HISTORIC AND DESIGN REVIEW COMMISSION

September 20, 2023

HDRC CASE NO: 2023-343
COMMON NAME: 958 E SOUTHCROSS
ADDRESS: 2900 ROOSEVELT AVE
2901 ROOSEVELT AVE
2835 ROOSEVELT AVE
1018 E SOUTHCROSS BLVD
992 E SOUTHCROSS BLVD
LEGAL DESCRIPTION: NCB 7674 BLK E LOT E PT & MID PT OF TR-1
NCB 7674 BLK C LOT W PT OF 1R & 2A EXC NE TRI 50 FT X 90 FT
NCB 7665 SE IRR 153.6 FT OF NE IRR 211.3 FT OF SW 503.6 FT OF 12
& N TRI 73.67 FT OF
NCB 7665 (ICP INDUSTRIES SUBD), LOT 39
NCB 8628 BLK LOT 3 (PICKUP INC SUBDIVISION)
NCB 7665 BLK LOT 16
ZONING: MXD, H, RIO-5
CITY COUNCIL DIST.: 3
DISTRICT: Mission Historic District
APPLICANT: Michael Clancy/Alamo Architects
OWNER: James Lifshutz/TEXAS HOME MORTGAGE INC
TYPE OF WORK: Construction of a mixed-use development with multiple structures, site and landscaping modifications
APPLICATION RECEIVED: August 18, 2023
60-DAY REVIEW: October 17, 2023
CASE MANAGER: Edward Hall
REQUEST:

San Jose Village

SAN JOSE VILLAGE
PRELIMINARY TREE PRESERVATION

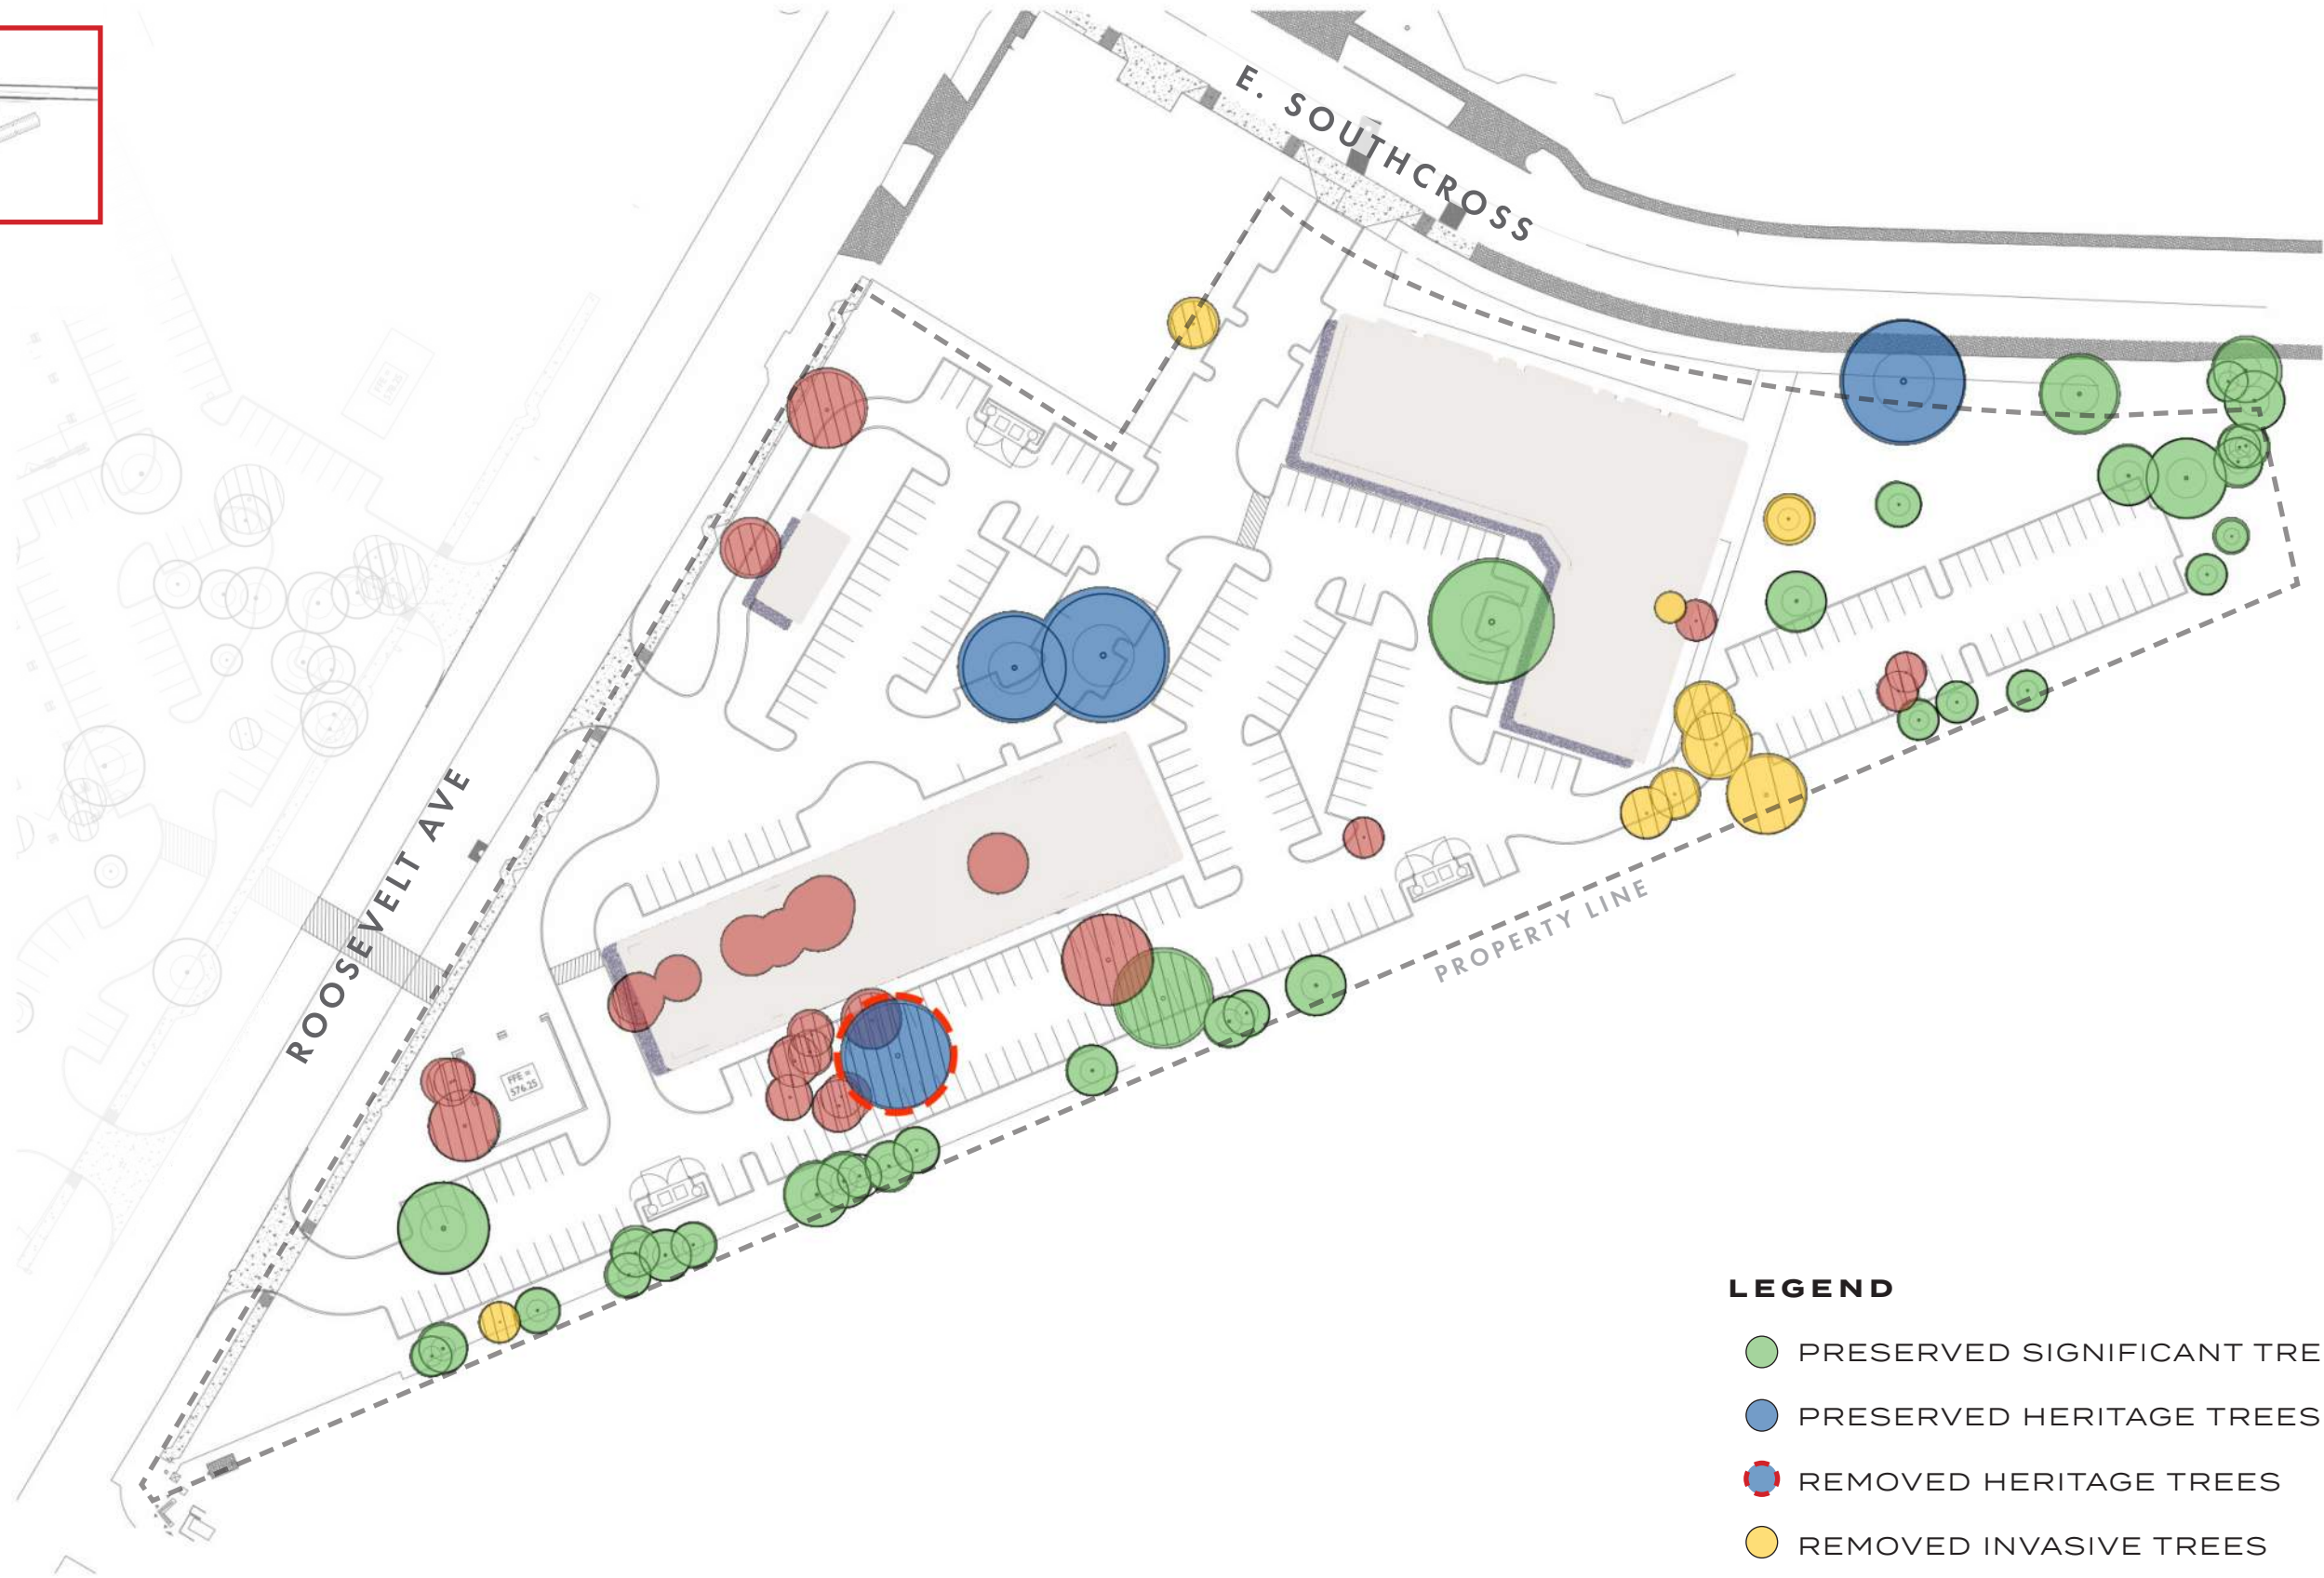
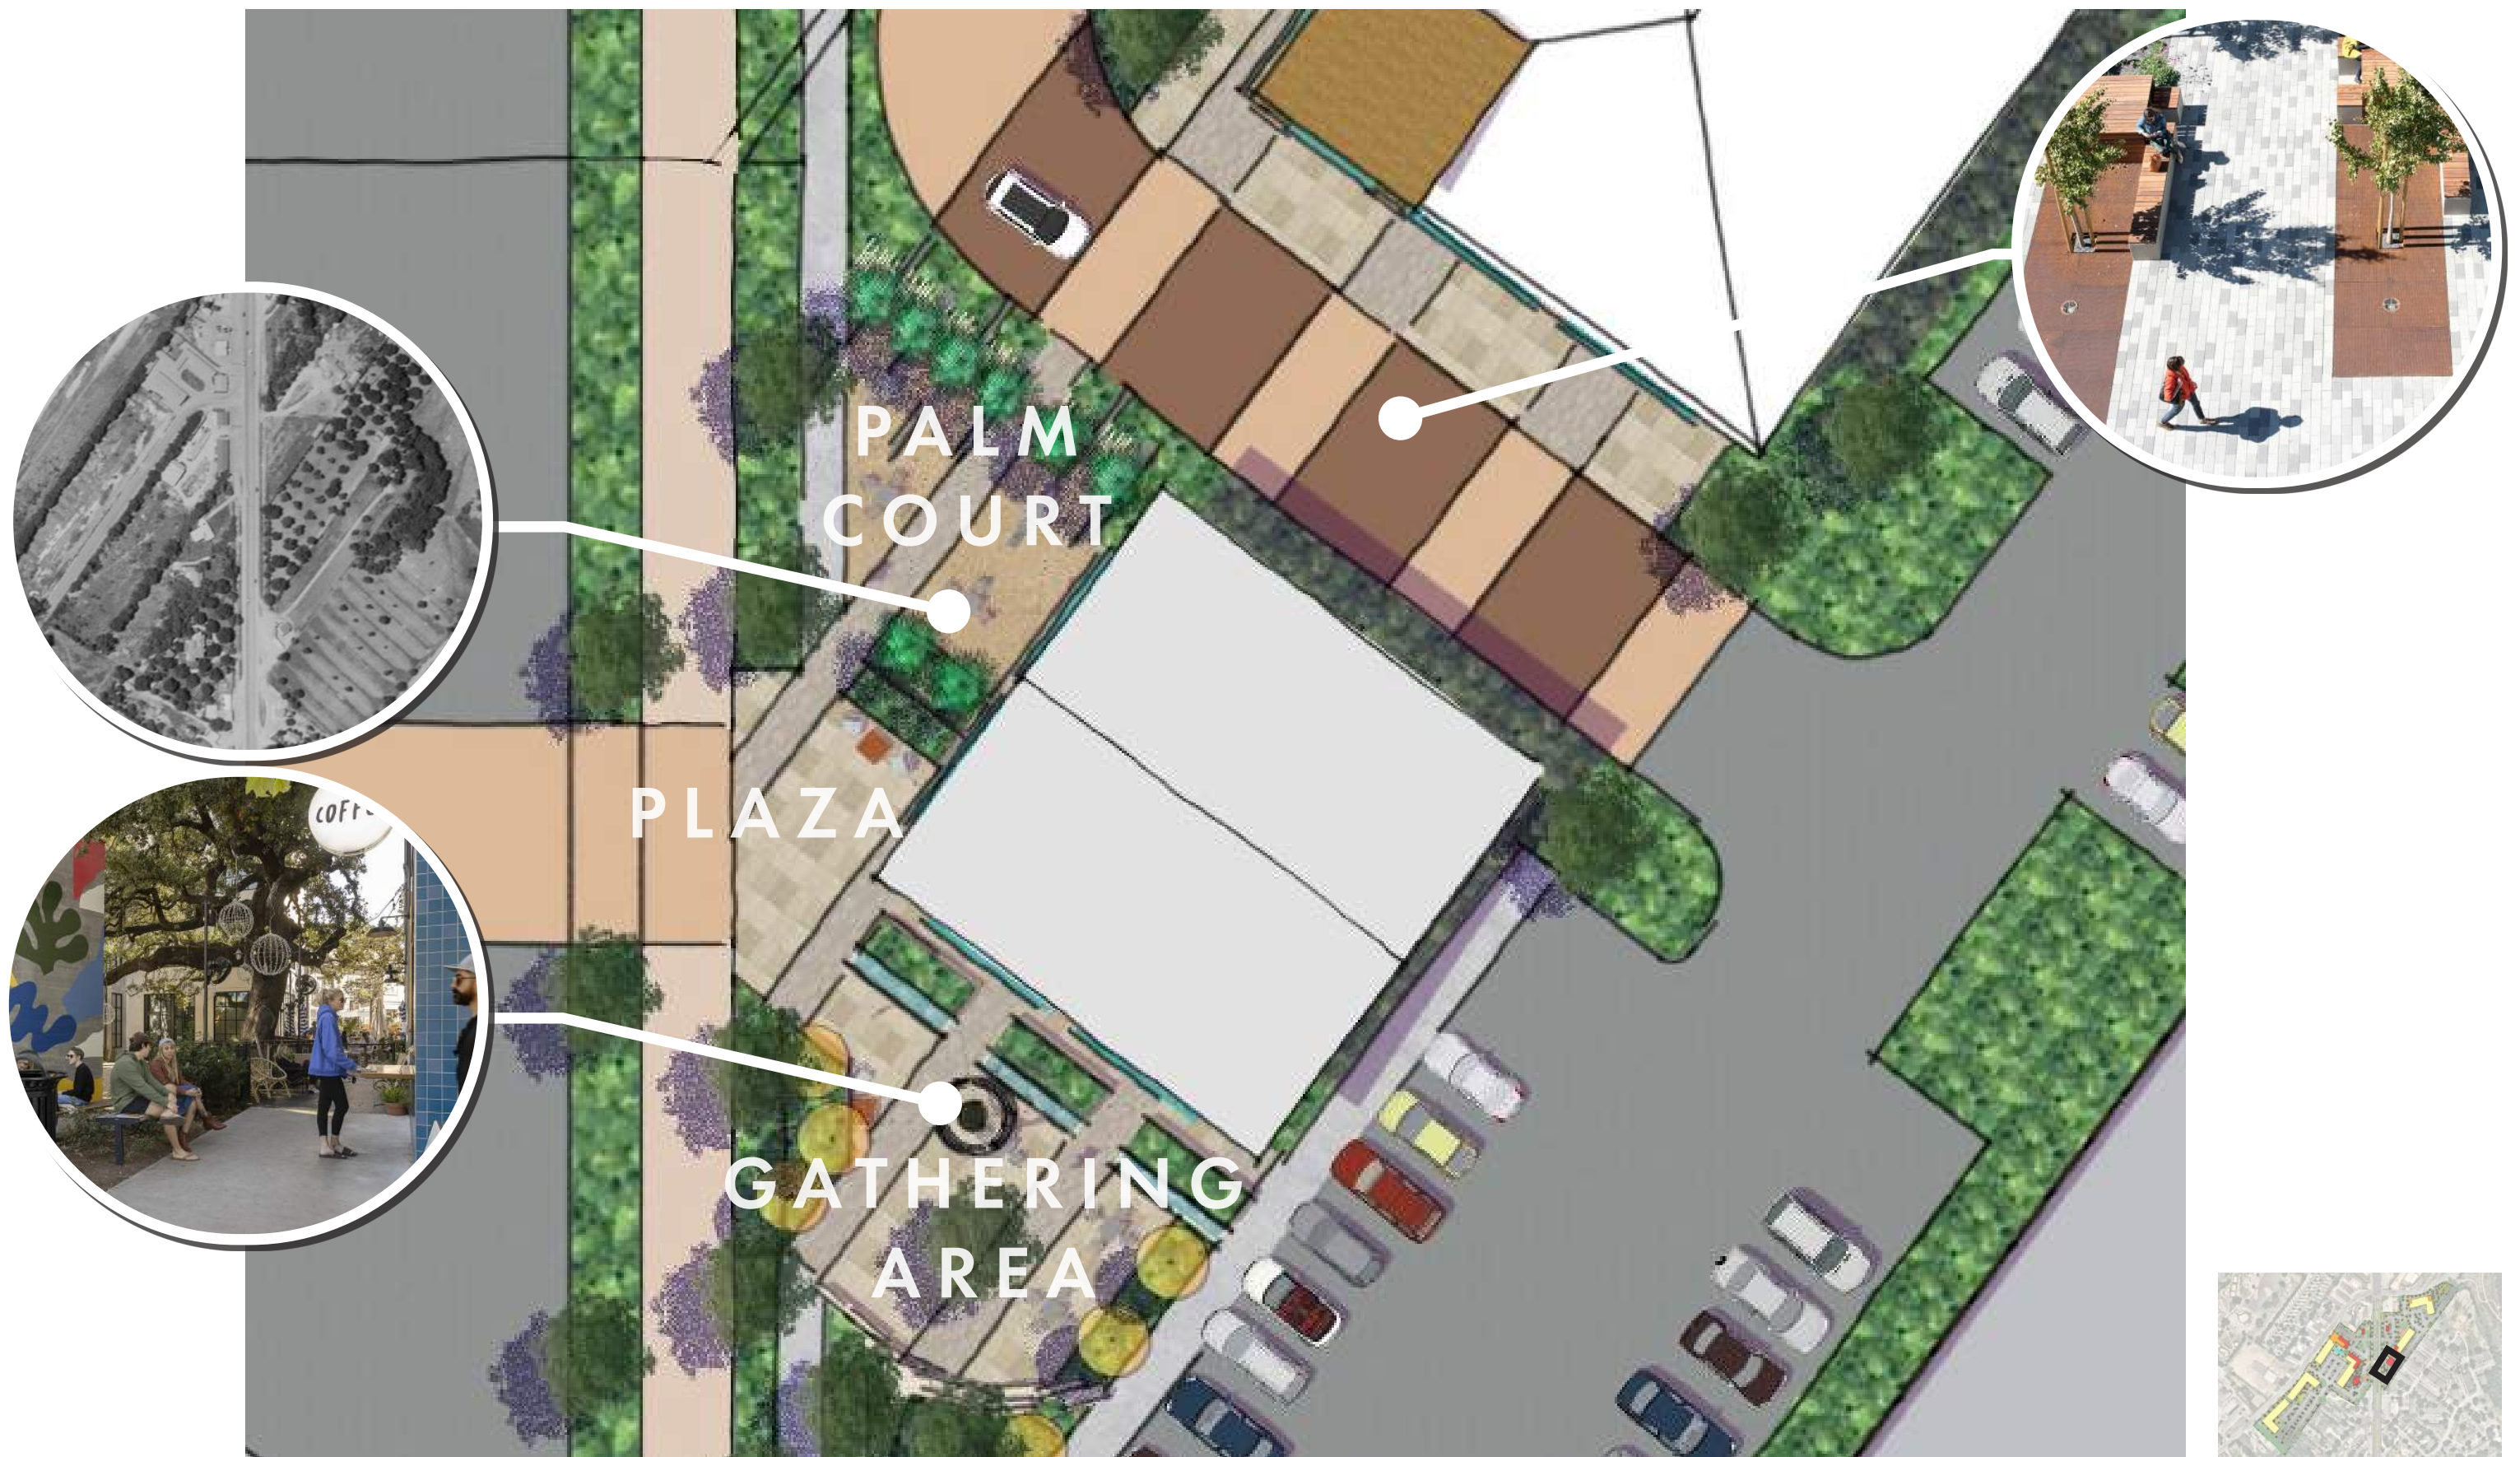
- u. **TREE REMOVAL** – The applicant has noted the removal of two heritage trees. These trees will be removed to accommodate site parking and vehicular access. Staff finds that all tree preservation and mitigation requirements should be met regarding the removal of two heritage trees.
